Application for Works Approval

Works Approval Number W3118/2025/1

Applicant Mid-West Ports Authority

Premises Geraldton Port
Marine Terrace, West End
GERALDTON WA 6530

Figure 5: Berth 6 Drainage system and new outfalls.

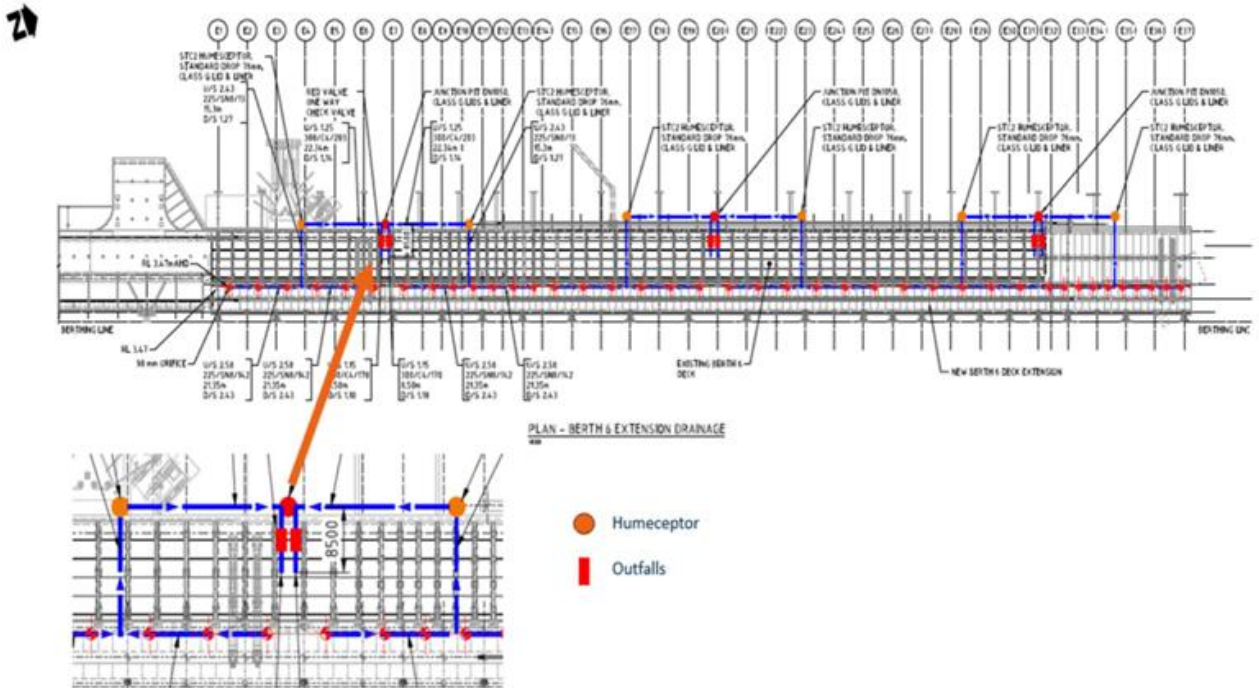
The licence currently authorises stormwater discharges to port waters via various outfalls (SW1 – SW17). SW14 is associated with stormwater discharge from Berth 6 and the licence requires monitoring of this discharge when handling fertiliser to verify the content of nitrogen-based pollutants in the discharge. With the improved drainage and filtration system on Berth 6, the applicant considers that stormwater monitoring during loading / unloading of fertiliser at Berth 6 is no longer required (MWP, 2025).

Summary of public comment	Department's response
<p>The commenter outlines their view that the stormwater management infrastructure at the premises is insufficient. This includes:</p> <ul style="list-style-type: none"> - The level of treatment proposed through Humeceptor units and retention swales is insufficient for port operations contamination sources. - No discharge water quality criteria such as discharge limits, compliance criteria or receiving environment water quality objectives are specified. - Limited information regarding construction phase erosion and sediment controls are outlined specifically in relation to piling, dredging and berth construction works. 	<p>As discussed above and in section 2.4.5, the scope of the assessment is limited to works associated with prescribed activities on the premises. Activities such as dredging are not within scope and are managed under Part IV of the EP Act via MS 1272.</p> <p>The delegated officer has undertaken an assessment of risks associated with stormwater as outlined in section 4.2. Factors considered in the assessment include:</p> <ul style="list-style-type: none"> • Existing licence controls for the management of spills and marine environmental quality monitoring (sediment and water quality); • Product handling limitations at Berth 1; and • Infrastructure controls such as use of Humeceptors and isolation capabilities at Berth 6 and sediment fence at Berth 1 swale. <p>The delegated officer acknowledged that the MEMMP and DEMMP establish frameworks for monitoring and managing impacts to port waters. The delegated officer identified gaps in these water quality monitoring programs and applied conditions on the works approval to address this through TLO. These requirements will be reviewed and refined through the assessment of the licence application.</p>

Condition 9, Table 5	<p>The applicant provided further context and requested the removal of the requirement for monitoring SW18-SW20 (as drafted).</p> <p>Rationale: The applicant advised that the stormwater discharge does not occur during fertiliser or metal concentrate loading activities. During loading of granular product, the relevant system is isolated to prevent any release, and all captured water, including stormwater and washdown water, is contained and removed off-site.</p>	The delegated officer acknowledges the comments provided by the applicant that further clarified the operations of the stormwater system during loading activities. Noting the stormwater system is designed and operated as a closed system, this additional control, as initially drafted, is not required and as a result has been removed.
Condition 9, Table 5	<p>The applicant requested the changes to the sampling frequency from monthly to quarterly.</p> <p>Rationale: The applicant advised that the OTHD monitoring location does not represent an active discharge point until completion of the capital dredging works and is therefore not relevant during the berth construction stage covered by this approval. While the applicant is amenable to inclusion of this monitoring point within the sampling program, it has requested that the monitoring frequency be reduced from monthly to quarterly to align with the existing requirements of the current licence.</p>	The delegated officer has accepted the proposed change in sampling frequency.

Figure 8: Locations of selected noise-sensitive receivers (R1 to R11)

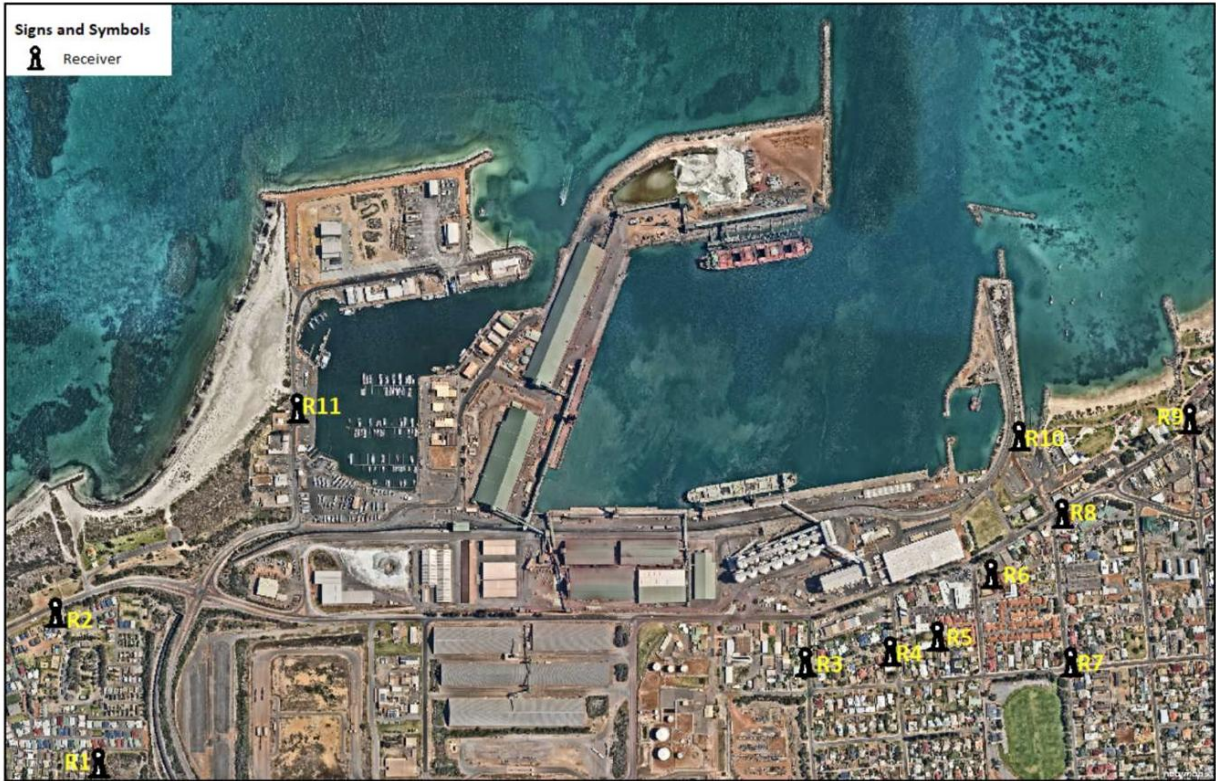
<p>Commenter raises that the noise assessment contains scientifically problematic claims relating to background noise levels. The commenter outlines:</p> <ul style="list-style-type: none"> - High existing background noise does not justify the addition of further noise impact. - The argument that noise will be "masked" ignores the character and temporal patterns of construction noise. - The assessment does not consider sleep disturbance impacts during nighttime dredging operations. 	<p>To provide greater certainty, the works approval requires the applicant to undertake noise validation monitoring during commissioning and operation to verify the model predictions. This ensures that compliance is assessed based on measured performance rather than predicted outcomes alone. Where monitoring identifies actual non-compliance, the applicant is required to investigate the cause and implement appropriate mitigation measures, ensuring a clear and enforceable process to address verified impacts rather than relying solely on conservative, modelled exceedances.</p>
